October 17, 2016

**Re: California Department of Water Resources' Final Recommendation Re
Basin Boundary Modification Request for San Jacinto Basin (No. 8-05)**

Proposed Bulletin 118 Groundwater Basin 8-05 (San Jacinto) Revision EMWD Service Area and Local Water Agencies

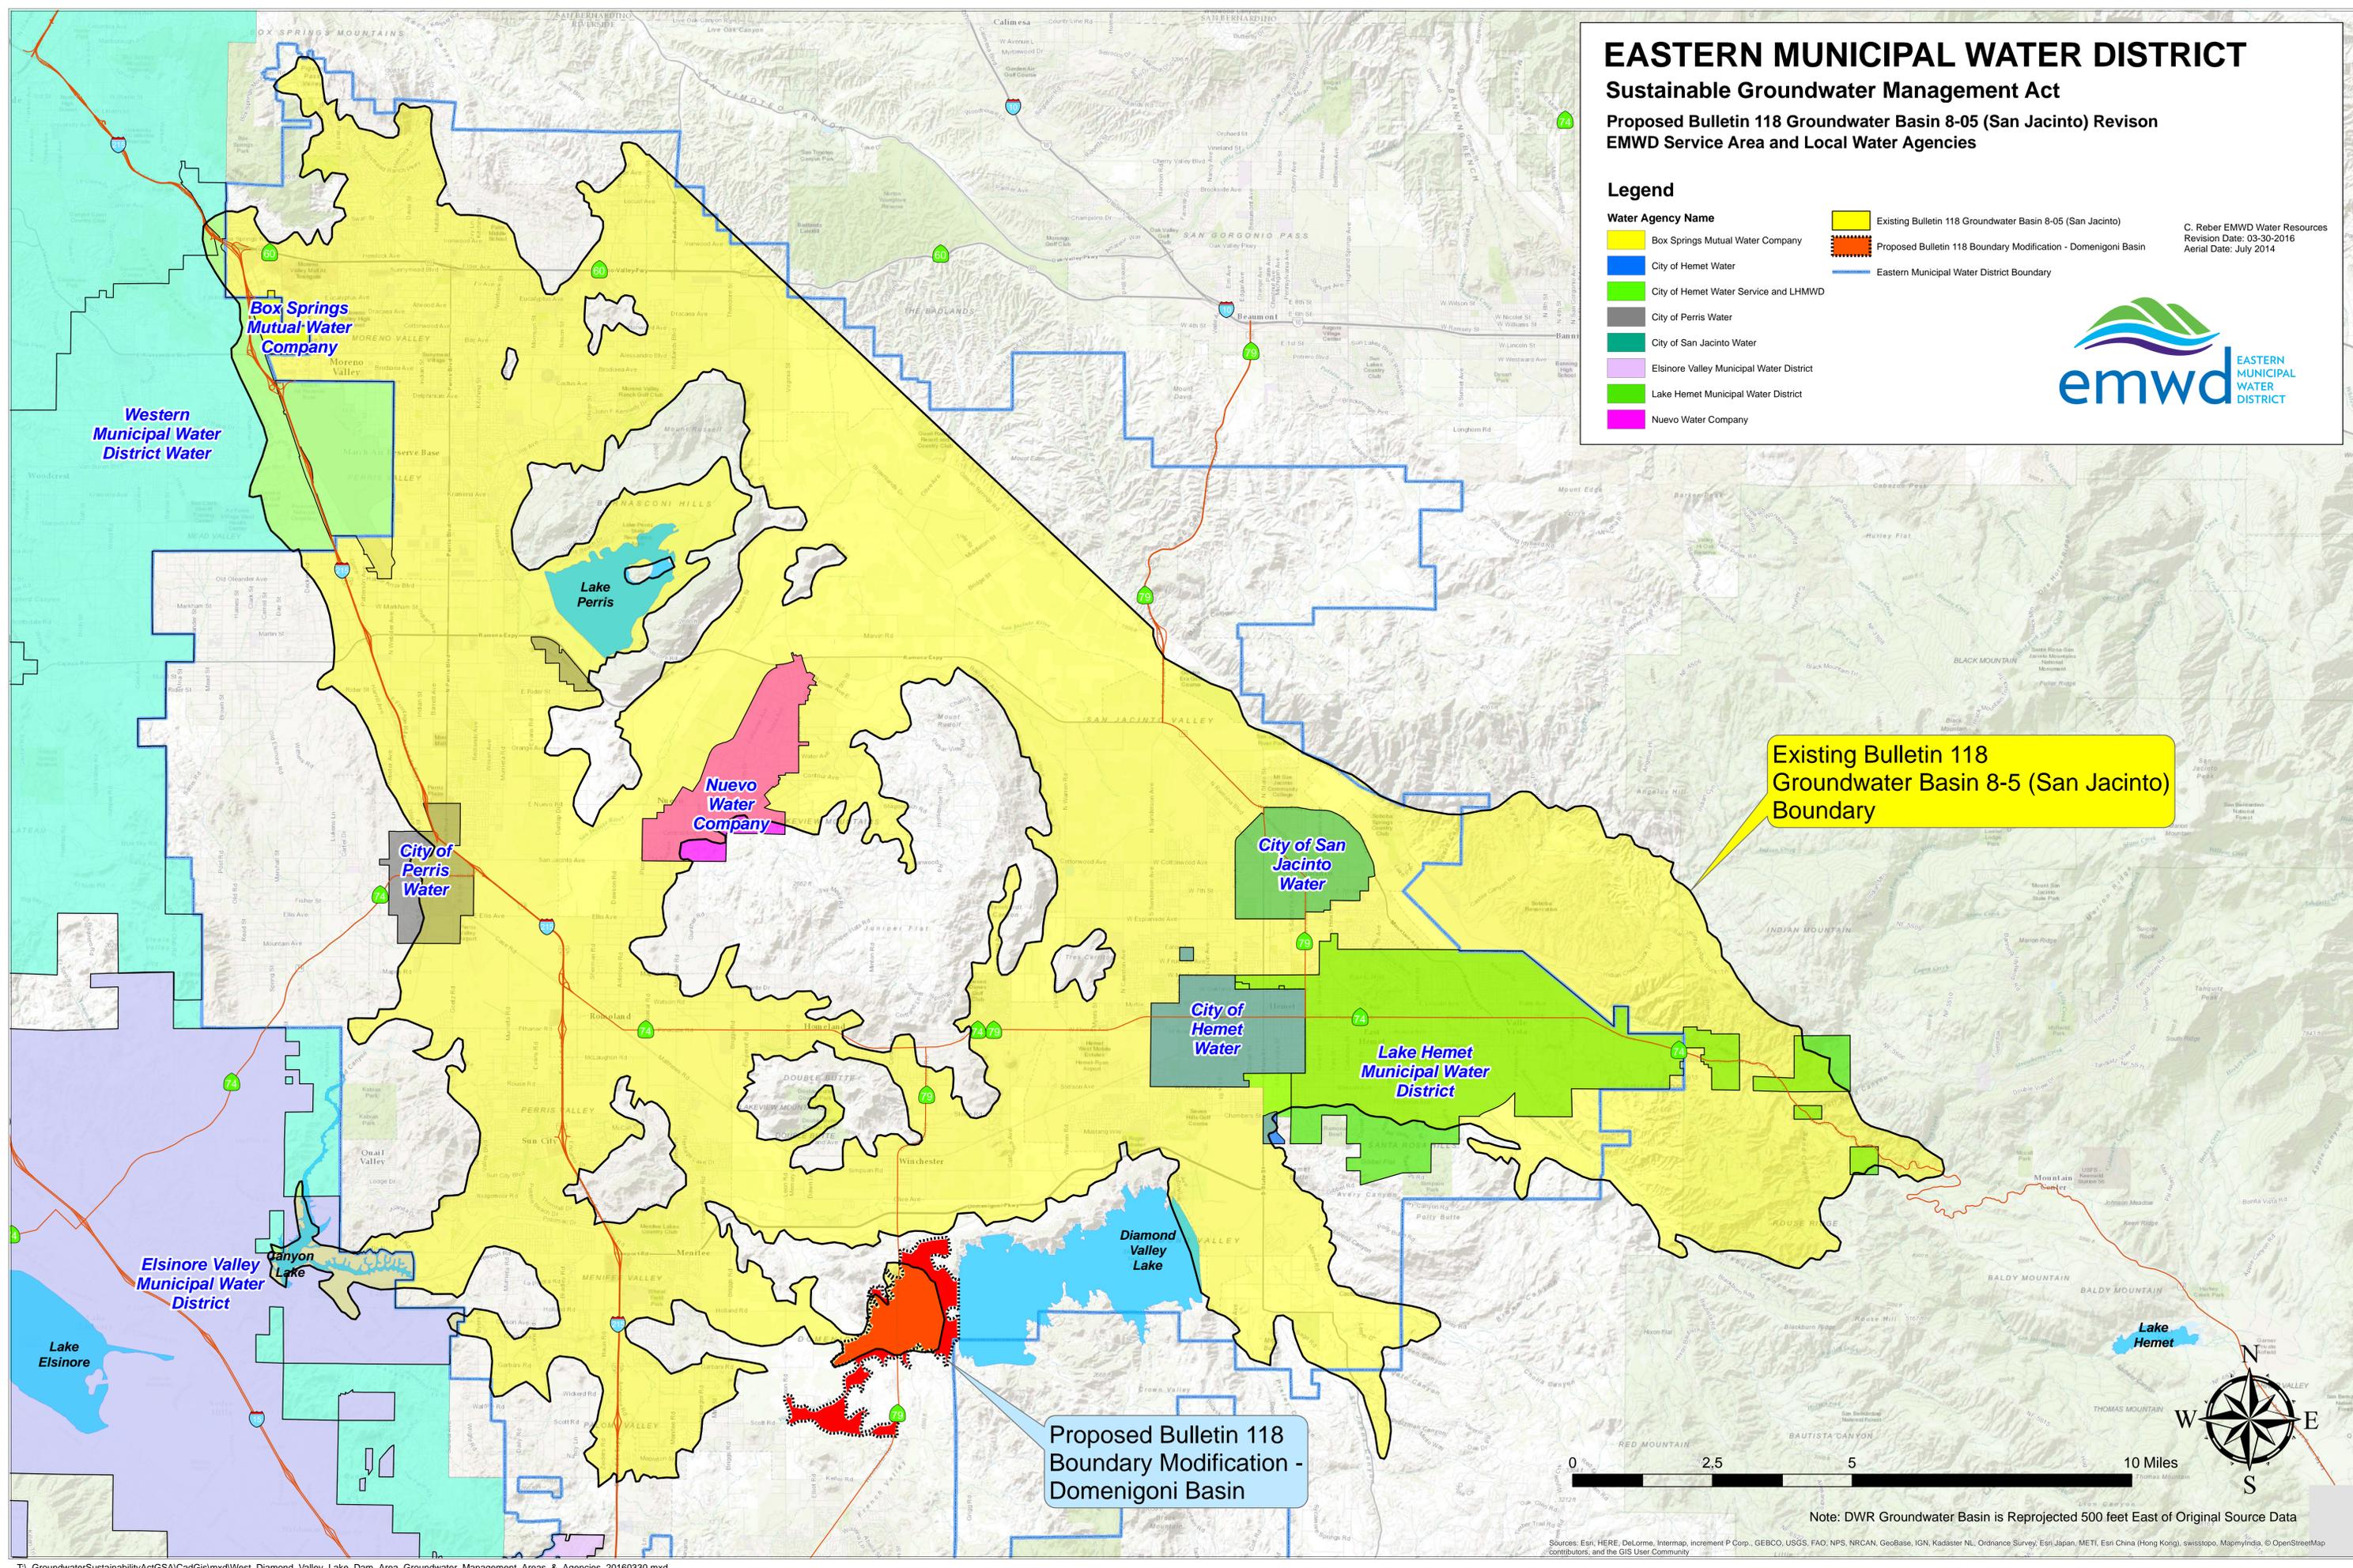
The local water supplier, Eastern Municipal Water District ("EMWD") submitted a request for a Basin Boundary Modification to align the San Jacinto Basin with the adjudication boundary by including two alluvial areas within the San Jacinto Basin: the upper Domenigoni Valley area and the Southern basin area. **Attachment 1** shows these basin areas (Basin Boundary Modification Request, Attachment D.3 [map]). DWR's Final Recommendation for EMWD's Request is "Approved, as modified".

The Domenigoni-Bartons support approval of DWR's Final Recommendation for the upper Domenigoni Valley portion of the San Jacinto Basin Boundary Modification Request, but request that DWR reconsider the request to include the Southern basin area modification under the correct evaluation criteria; and that CWC and DWR review the public notification and comment processes employed in this round of basin boundary modifications in order to improve public participation in time for the 2018 cycle of boundary modification requests.

However, the newer and more detailed 2003 USGS/CGS geological mapping actually confirms the presence of alluvium in the Southern basin area supporting EMWD's Request. DWR's Final Recommendation for EMWD's Request maintains its preliminary recommendation to "Approve, as Modified" – omitting the Southern basin area and approving only the upper Domenigoni Valley area – without addressing the procedural and substantive errors raised in our July 14, 2016 letter.

However, the Google Earth images used by DWR to disapprove the Southern basin area portion of the Request are not "Qualified Maps" because they are unpublished satellite images viewed through the internet. Furthermore, DWR applied an arbitrary "minimum alluvial thickness" standard instead of evaluating whether the Southern basin area had a "presence or absence of a groundwater flow boundary." (§ 345.4(a)(2)-(3).)

In light of the above, we ask DWR to reconsider the Southern basin area modification under the correct evaluation criteria and approve EMWD's Request. Further, we respectfully request that CWC and DWR review the public notification and comment processes employed in this round of basin boundary modifications in order to improve the process for the 2018 cycle.
